Re: **RESPONSES TO FIRST REVIEW – ILIFF STATION MULTI-FAMILY SITE PLAN MINOR AMENDMENT**
CASE NUMBER: 2015-4005-02

Enclosed herein is the second submittal for the Iliff Station Multi-Family Site Plan Minor Amendment. The comments that were provided February 13, 2018 have been addressed and are included with this letter.

SITE PLAN - SUBMITTAL
AURORA, COLORADO

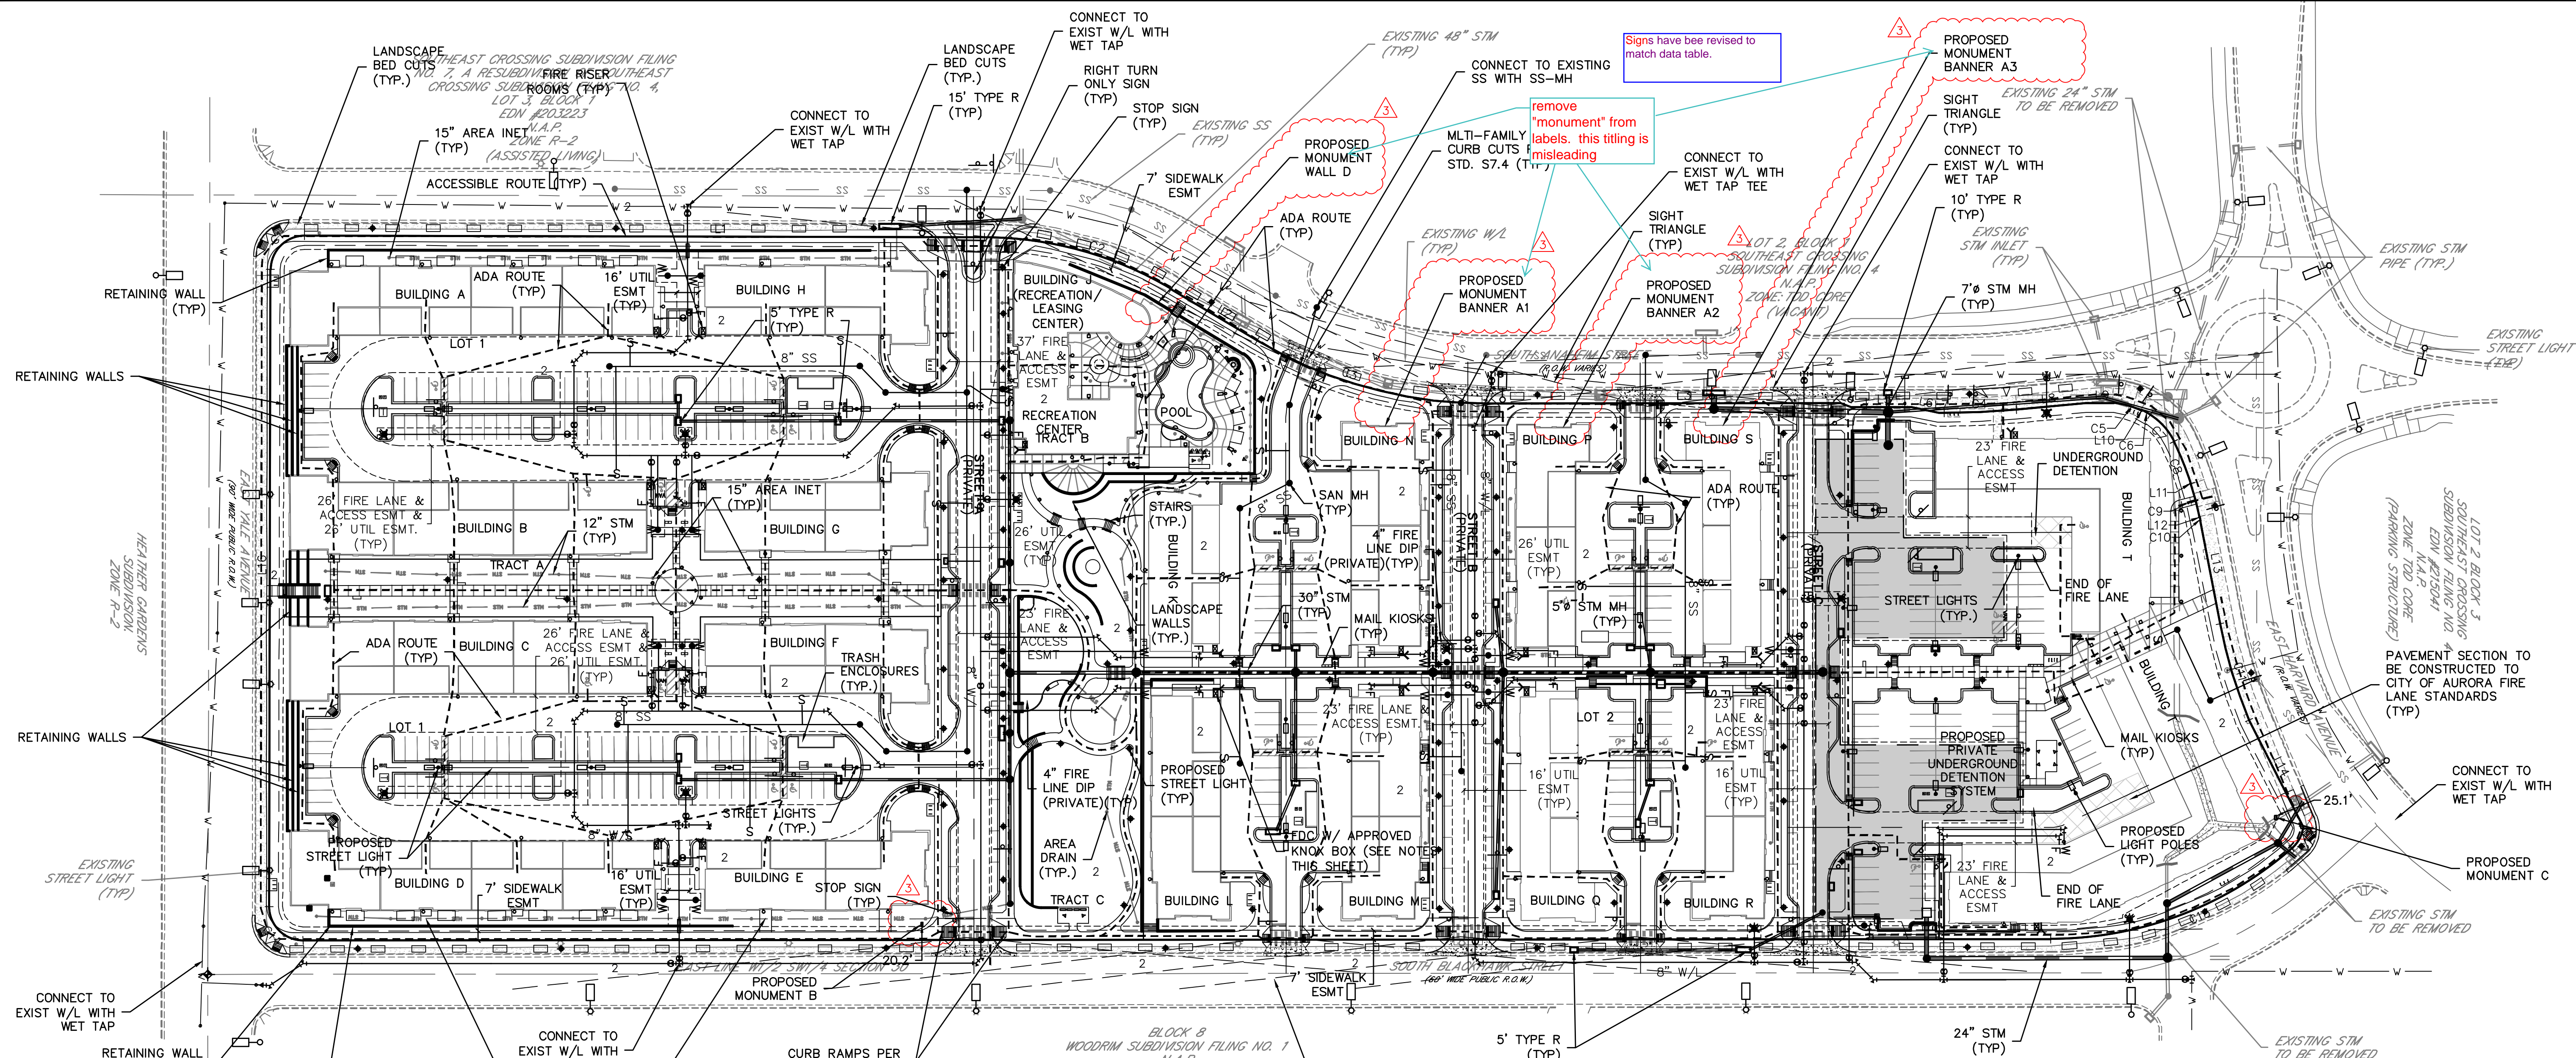
these are two-sided signs, please account for the sign area on both sign faces

illumination method must be changed to comply with code, see redline comments on details sheet

the maximum sign area allowed for project identification signs is 40 square feet, this sign must be reduced in size by 20 square feet

Sign areas have been revised to show single-side(SFO and Dual-Sided (DF) Areas

these areas have been revised to show single-side(SFO and Dual-Sided (DF) Areas

Sign areas have been revised to show single-side(SFO and Dual-Sided (DF) Areas

The sign has been reduced.

L1.01

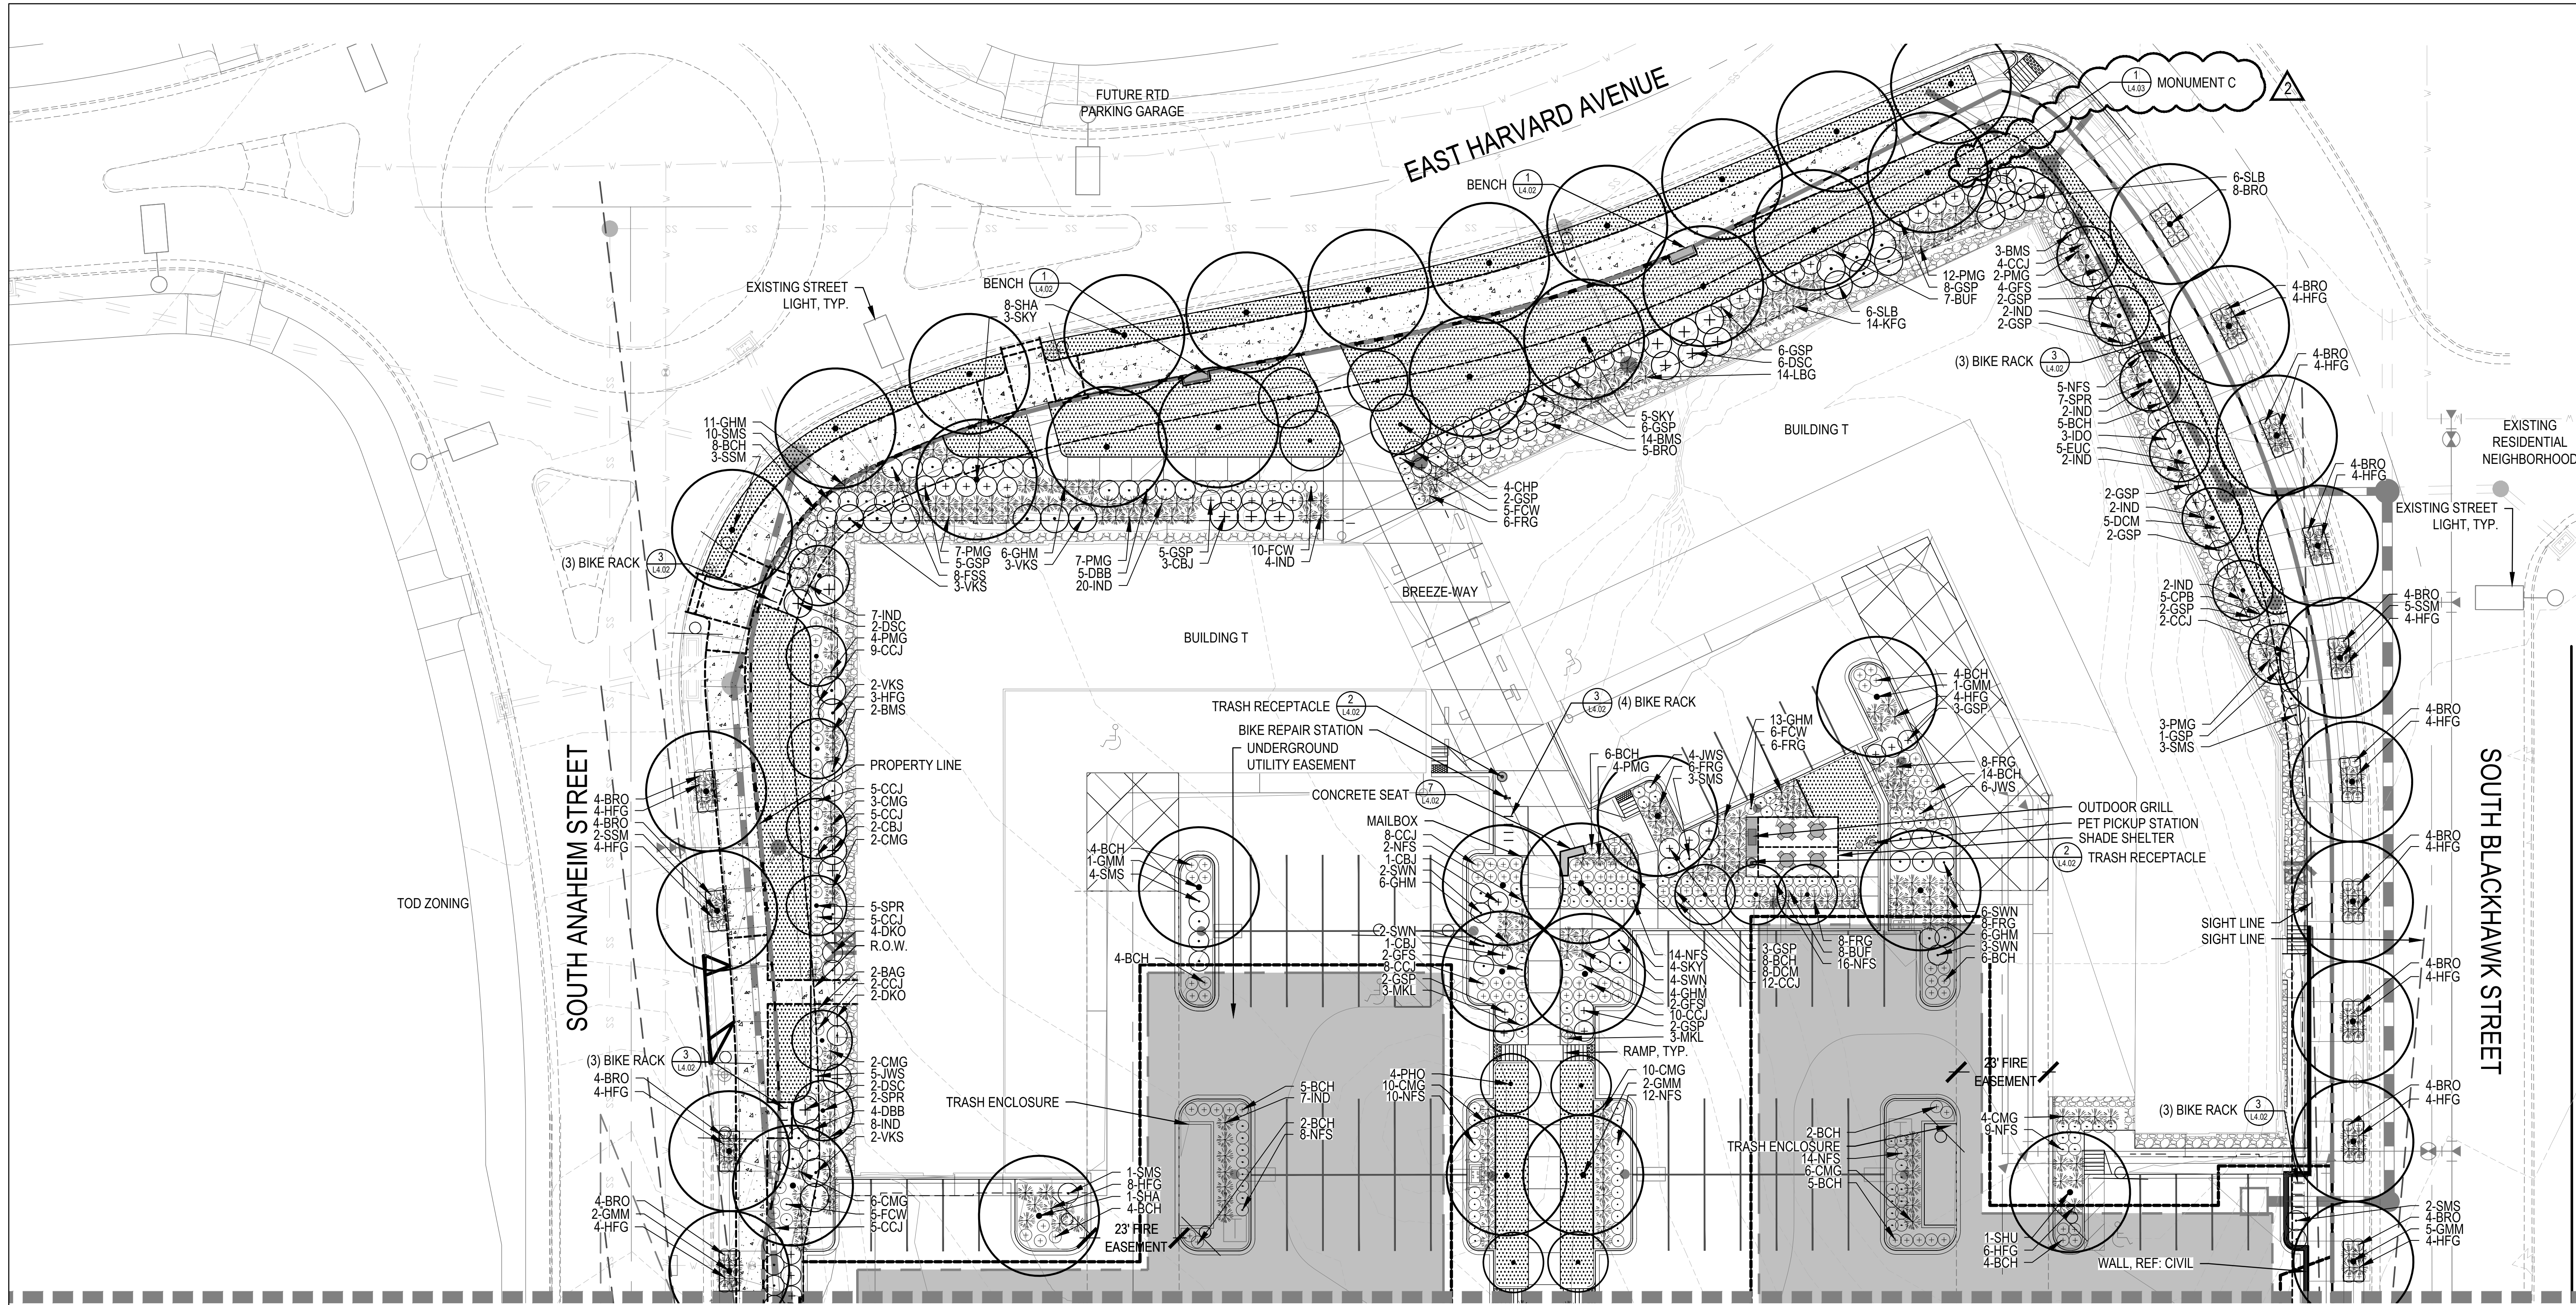
- Please fix the text errors.

- Please correct the text error on Sheet L1.01.

Revised

text errors

1 MONUMENT C

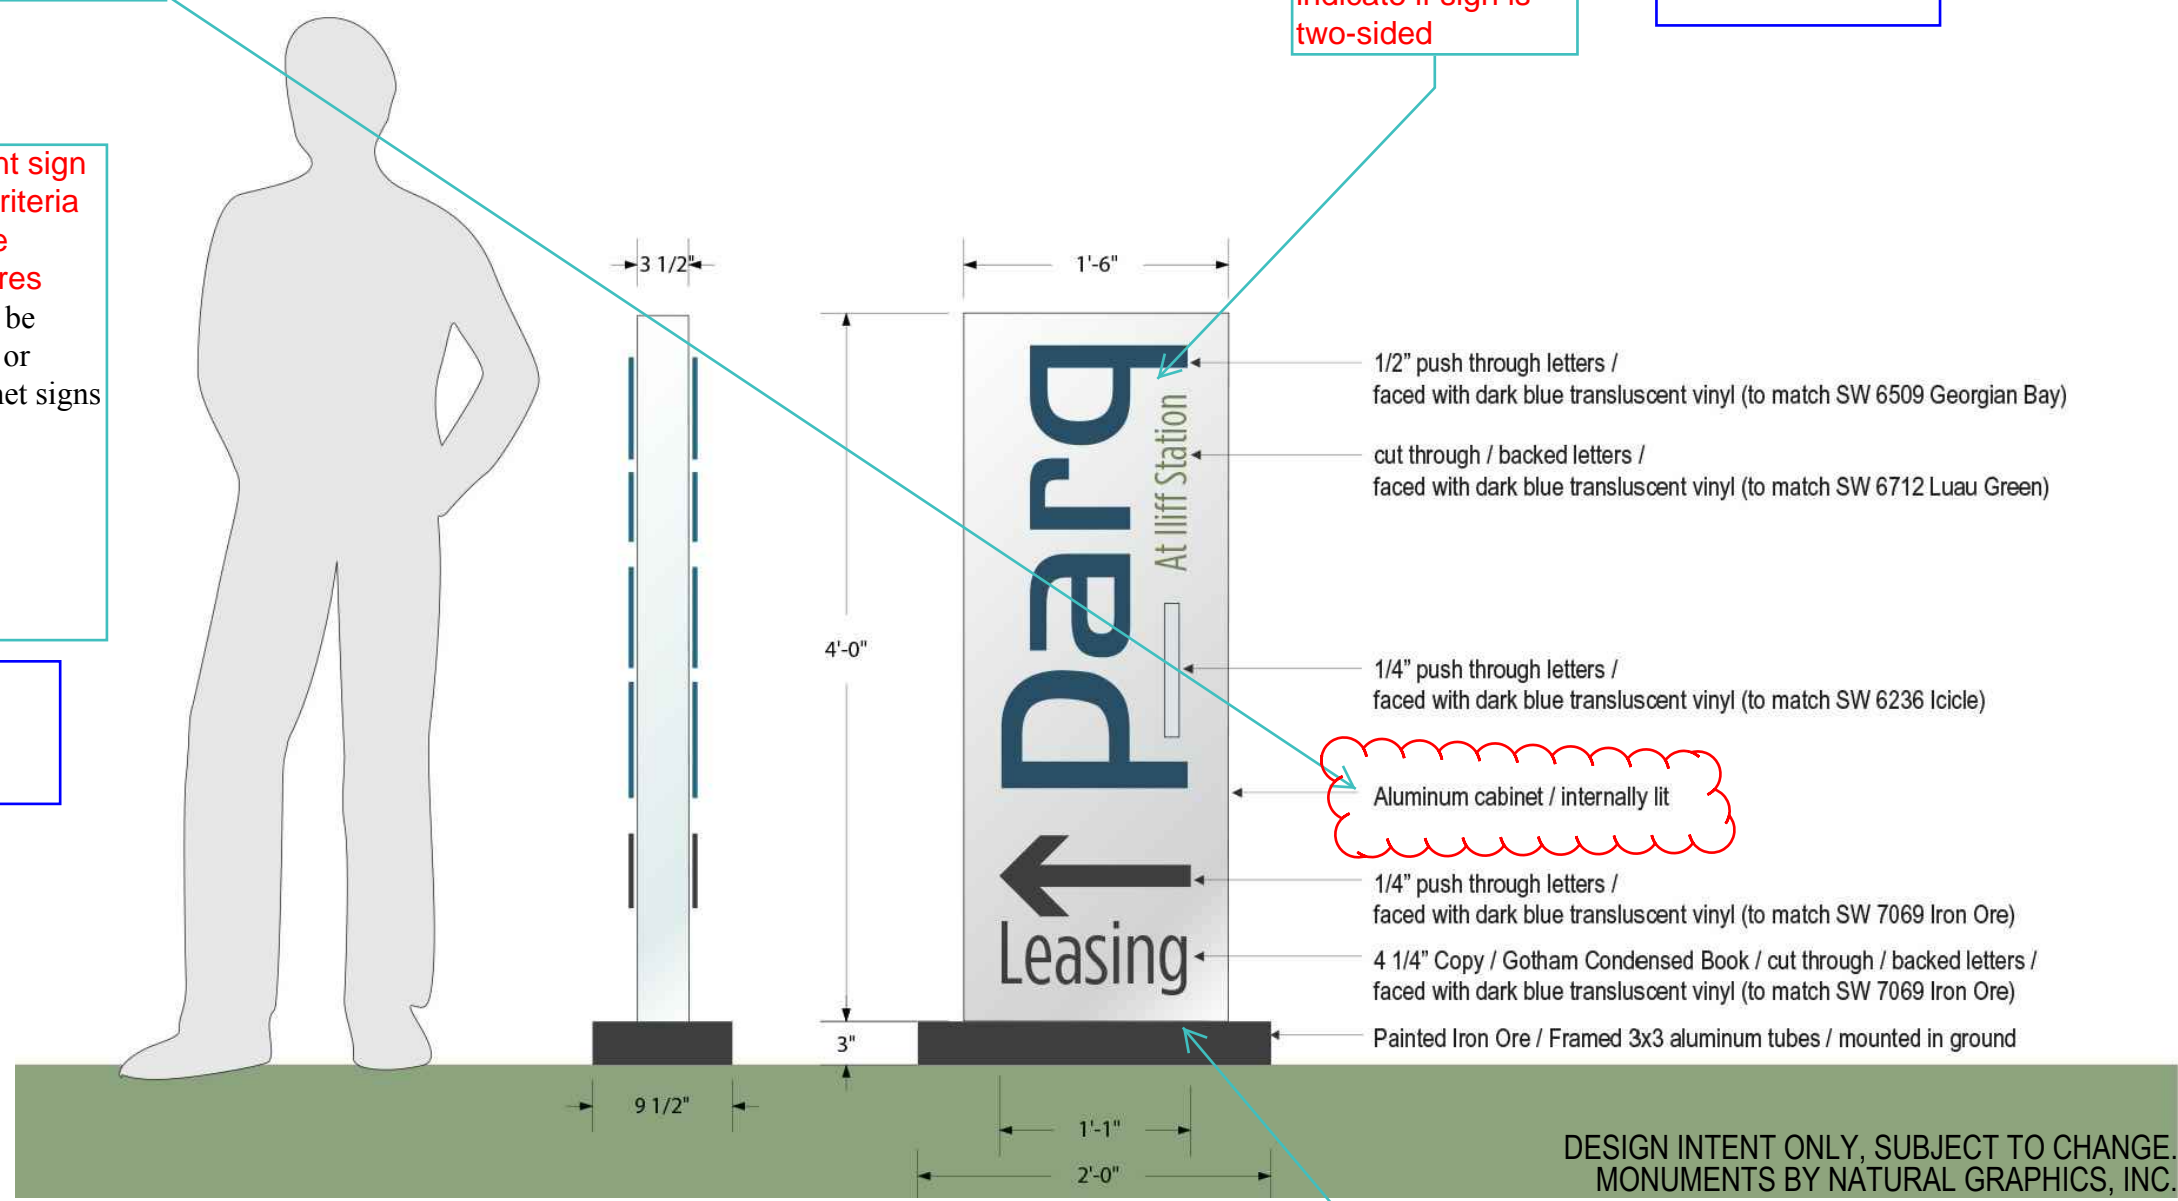
- The proposed internally illuminated monument signs must be revised to comply with illumination requirements. Per Code section 146-1614 "If a sign is to be illuminated, all letters on a sign shall be individually illuminated from an internal source, with the exception that wall signs are permitted to be illuminated entirely from downcast architectural lighting fixtures. A uniformly backlighted sign face is not permitted on any sign."

- Please revise monument sign lettering to meet code criteria regarding design. Code Section 146-1614 requires "All letters on a sign shall be individual 3-D, engraved, or projecting can type. Cabinet signs are not allowed."

Internally illuminated signage is not
permitted. Per Code section 146-1614
"If a sign is to be illuminated, all letters on
a sign shall be individually illuminated
from an internal source, with the exception
that wall signs are permitted to be
illuminated entirely from downcast
architectural lighting fixtures. A uniformly
backlighted sign face is not permitted on
any sign."

Please revise monument sign
lettering to meet code criteria
regarding design. Code
Section 146-1614 requires
"All letters on a sign shall be
individual 3-D, engraved, or
projecting can type. Cabinet signs
are not allowed"

Response: The signs have been revised to have back lit letters.

Response: The signs have been revised to meet code requirements.

Letters have been
revised.

Cabinets are no longer
illuminated. Letters
are back lit.
